RECEIPT DATE: 10-20-14 **ONSITE SEWAGE DISPOSAL SYSTEM** P 555279-A

PROPERTY ADDRESS: 14528 Edgewoods Way

SUBDIVISION: Edgewood Farm LOT: 57 TAX ID: \_\_\_\_\_

PLOT PLAN FOR BAT INSTALLATION  
LOT 57

14528  
Edgewoods  
Way

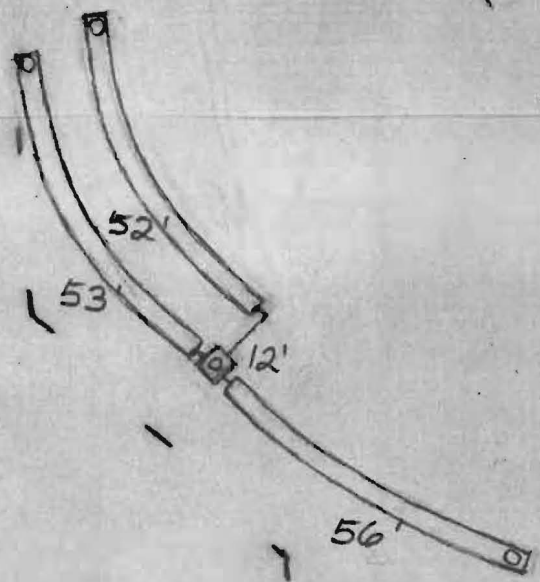
11/12/2014 Put tank just inside top corner of septic easement. Install three 53' trenches similar to plan. (BB)

INSTALLATION: 11/14/2014 Trenches and dist. box installed. No septic tank. (BB)

11/20/14 ~~septic~~ House connection not made. Need cleanout between tank and distribution box (total length = 80 ft.). Spoke with Kevin from Fogle's - they will add a cleanout. (SC/PR)

1/20/15 Everything was covered on site. Fogle's did install a cleanout between the tank and D-box. I couldn't verify house connection but we will accept pictures that Jake took. Needs BAT startup certification. (SC)

14528 Edgewoods Way

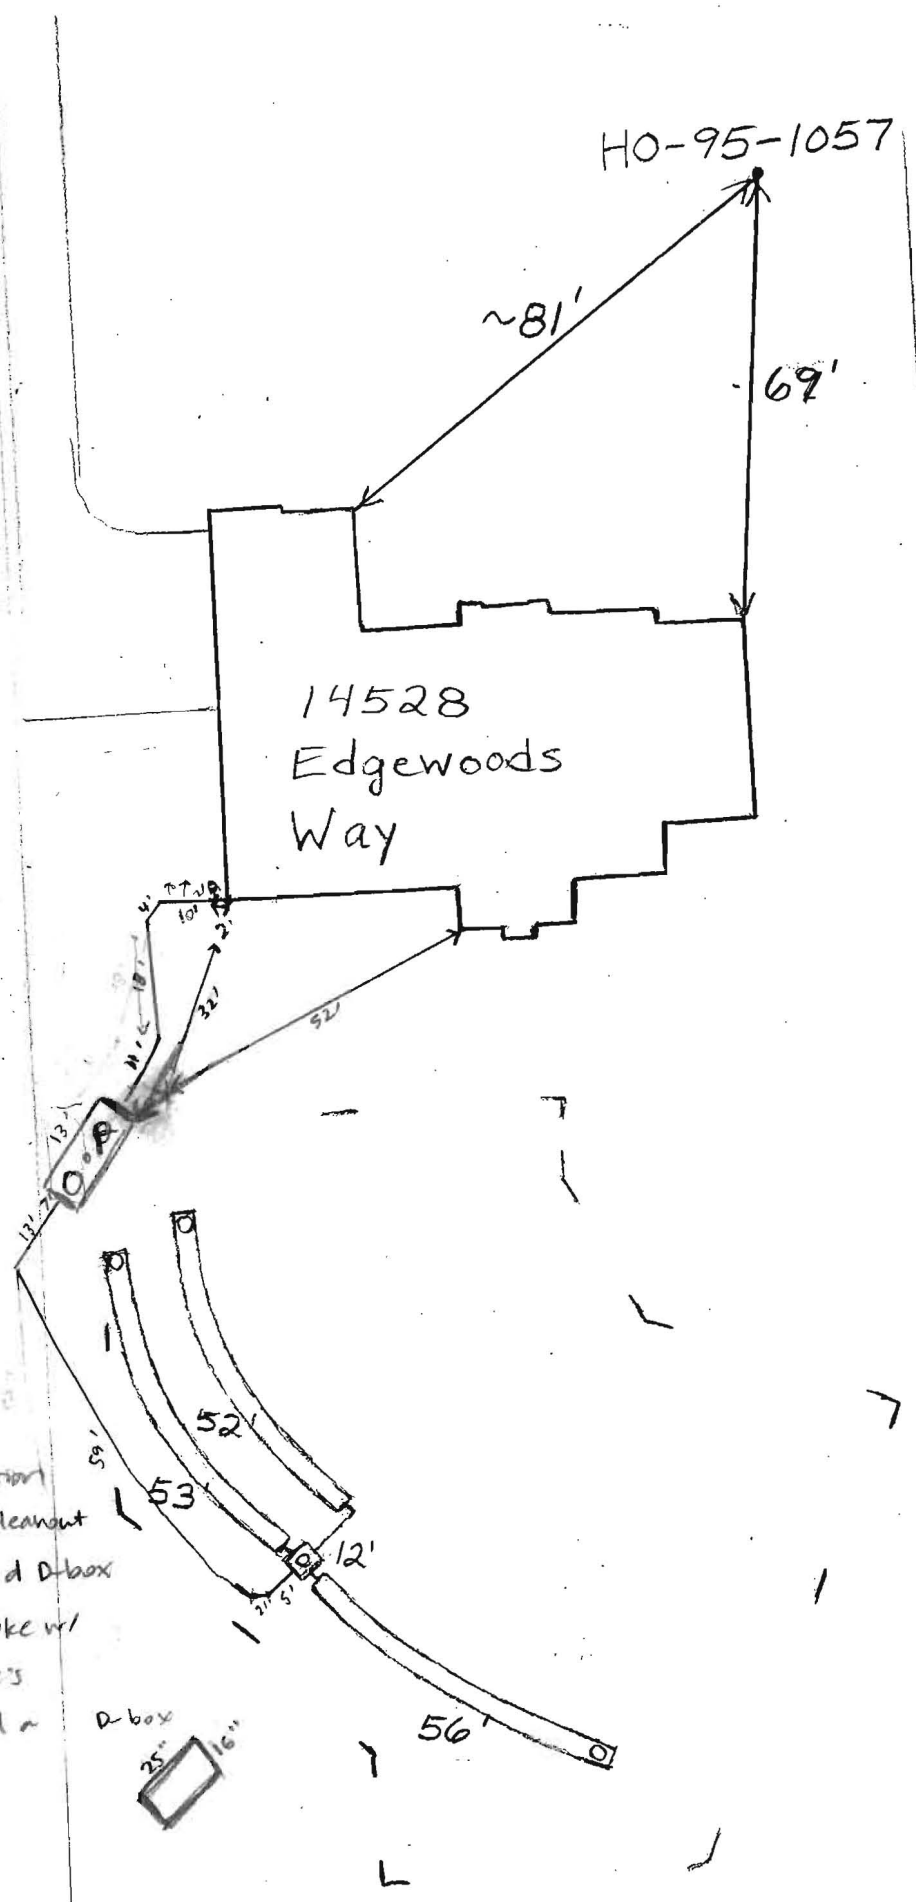
11/20/14  
 Sewerhouse connection  
 not made. Need cleanout  
 between tank and D-box  
 (total ~80'). Spoke w/  
 Kevin from Figley's  
 and they'll add a  
 cleanout.

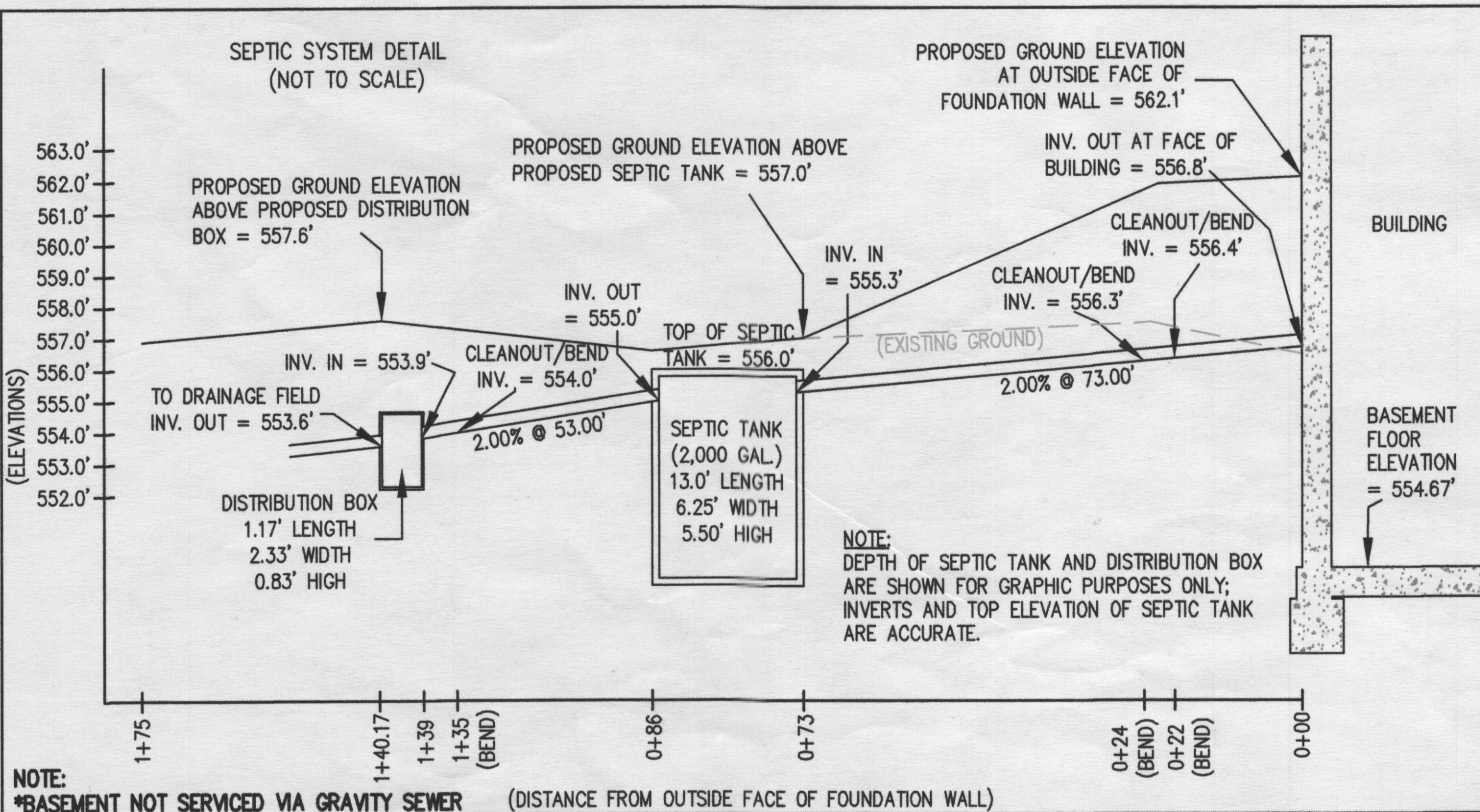
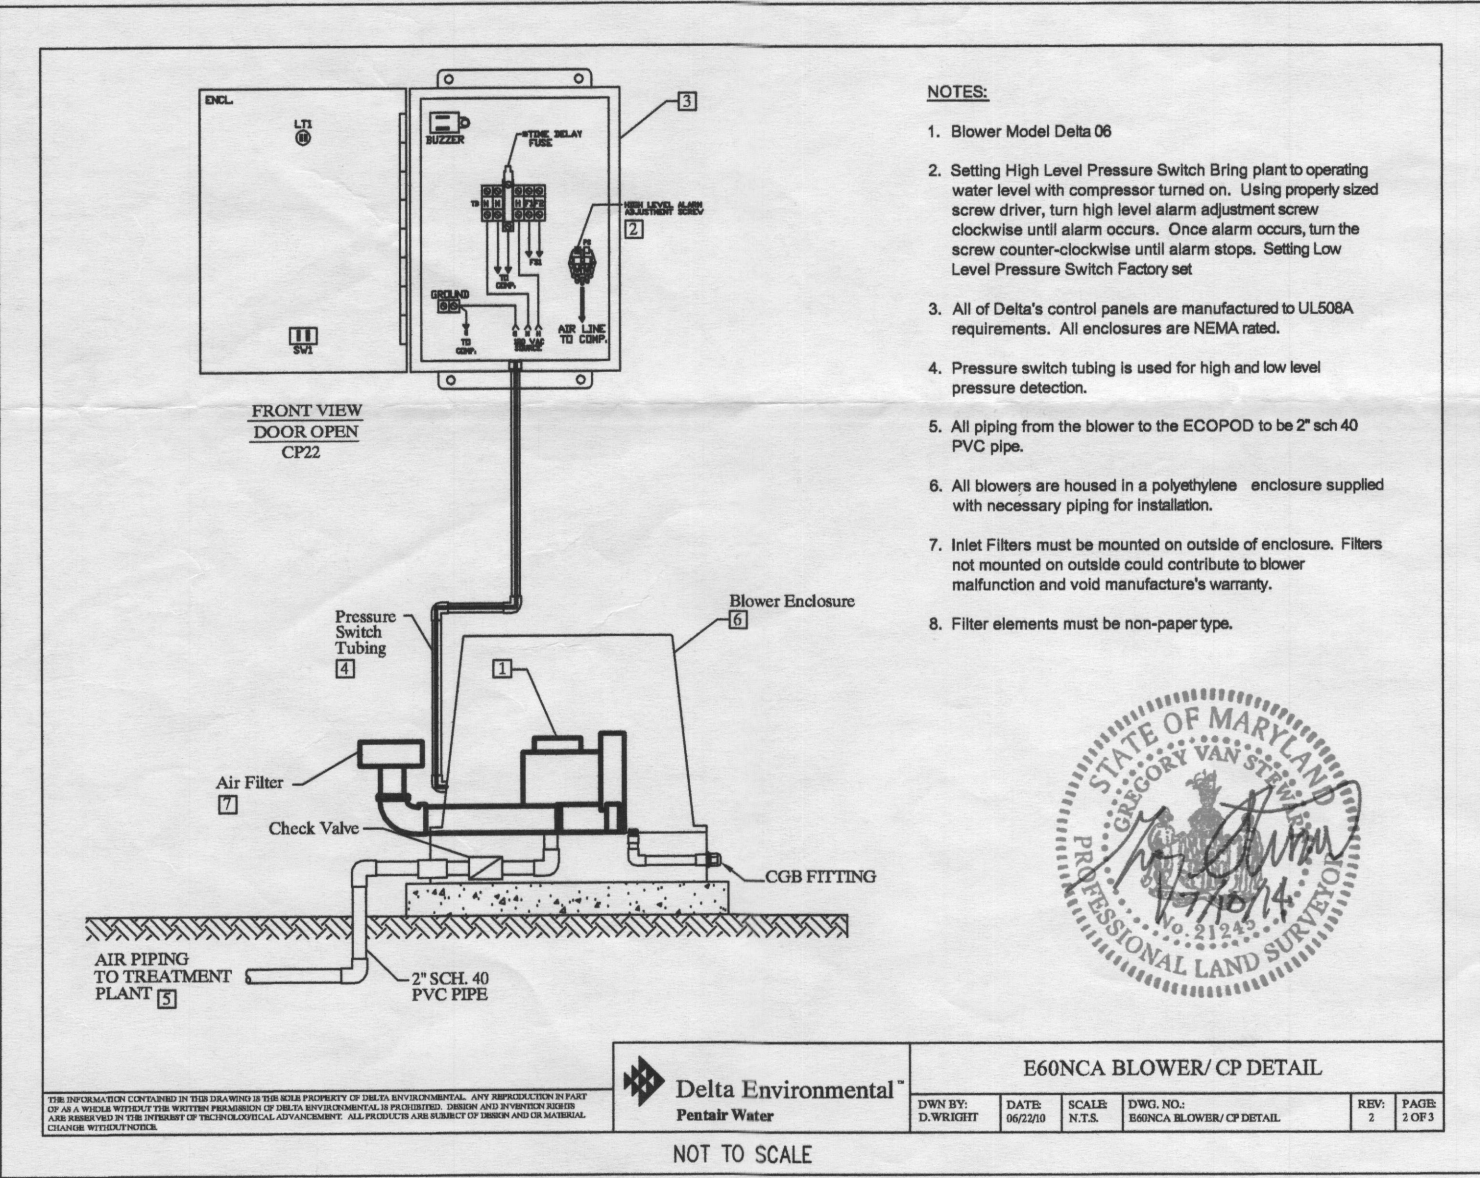
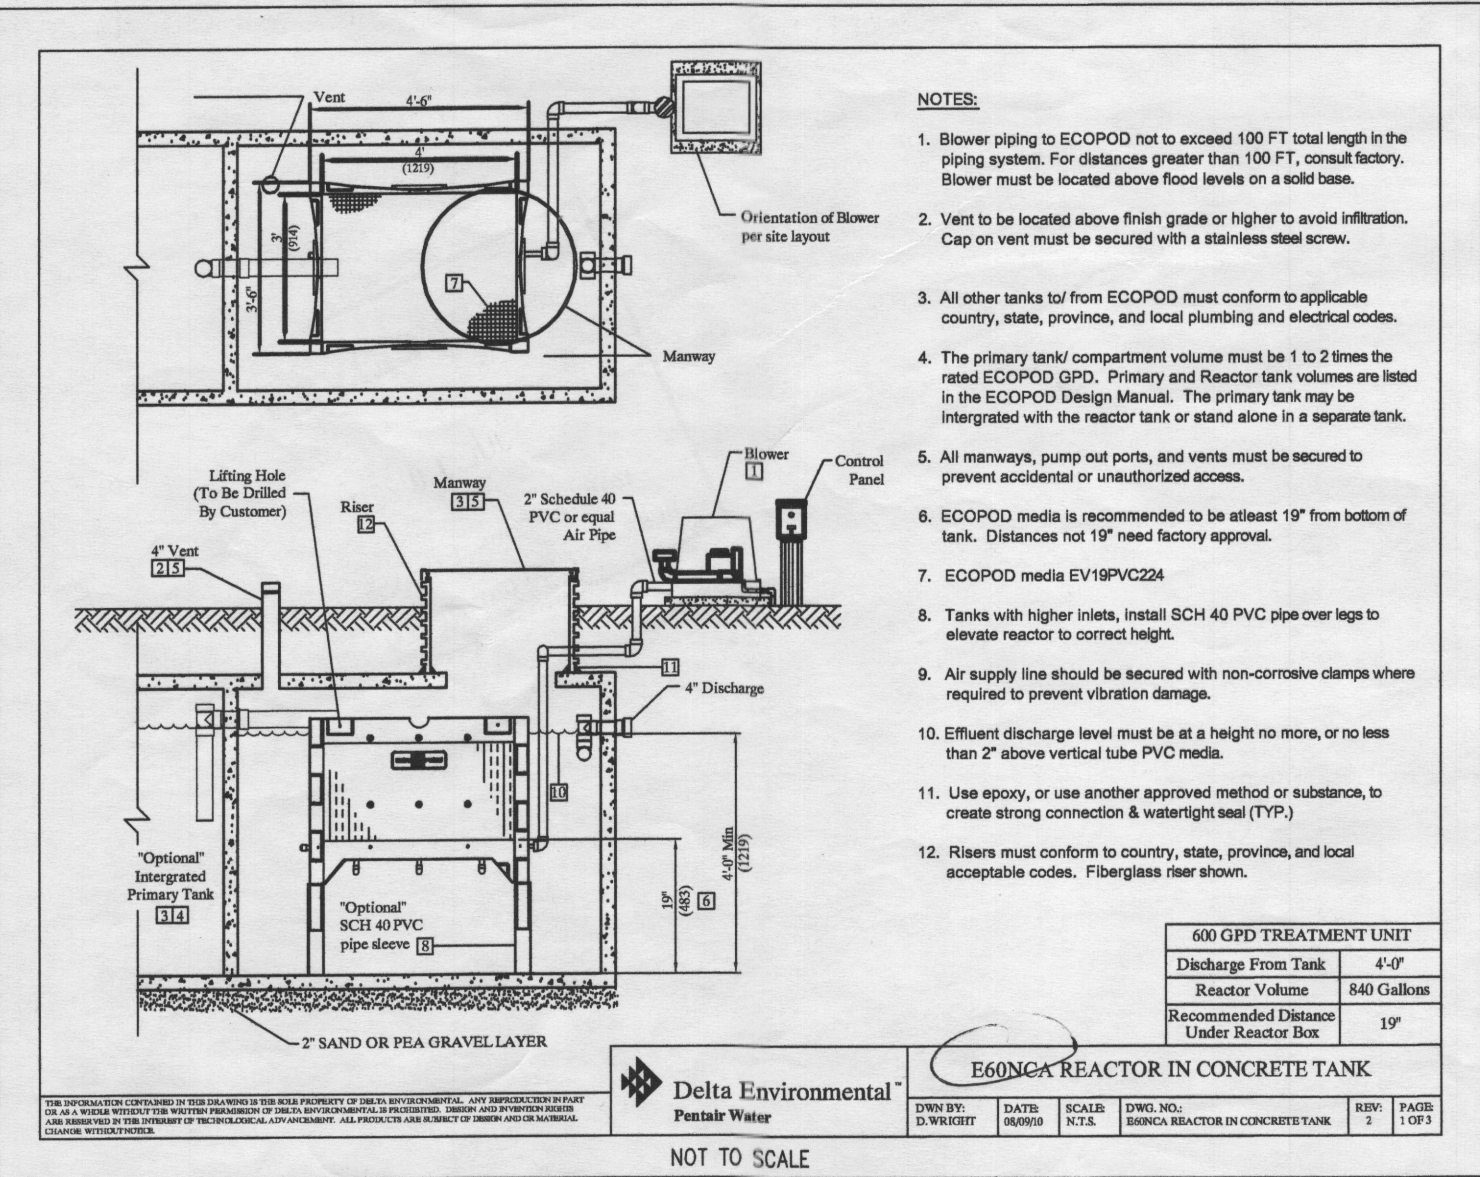
That looks fine. We will need to see the revision posted in Accela to verify the removal of the playroom. The current BP indicates the playroom. Once that is there, you can let me know and once I can verify it, we can sign off on the BP.

I spoke to our sales office and they'd rather keep the original floor plan with the playroom. I will have the BAT system redesigned for a 5 bedroom house.

Attached are the revised floor plans. I've changes the second floor to delete the playroom.
